**Proposal #12: 9115-02-71, WISC 2021 265**  
**T Underhill, CTH R**  
**Shawano County Line to CTH VV**  
**CTH R**  
**Oconto County**

This is Addendum No. 01, which provides for the following:

Addendum No. 01  
ID 9115-02-71  
Revised Sheet 4  
March 22, 2021

**CULVERT REPLACEMENT BEDDING DETAIL**

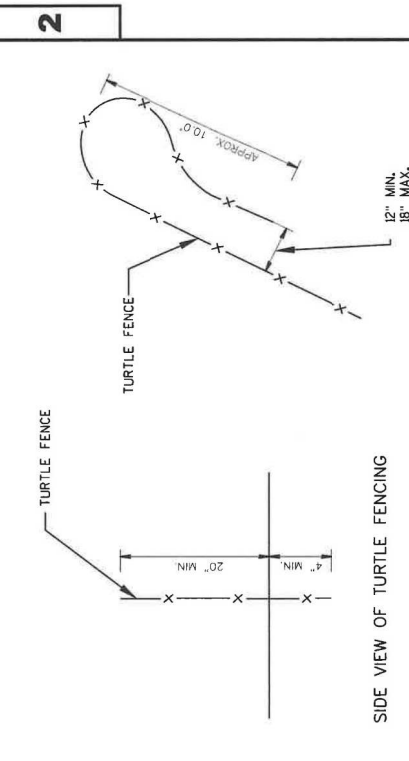
Revised Plan Sheets	
Plan Sheet	Plan Sheet Title (brief description of changes to sheet)
4	Construction Details – Pipe Bedding Detail added base aggregate and pavement thicknesses
10	Miscellaneous Quantities revised base aggregate dense 1 ¼-Inch quantity to include quantity at culvert pipe locations

1.75" HMA PAVEMENT 4 LT 58-345  
2.25" HMA PAVEMENT 3 LT 58-345
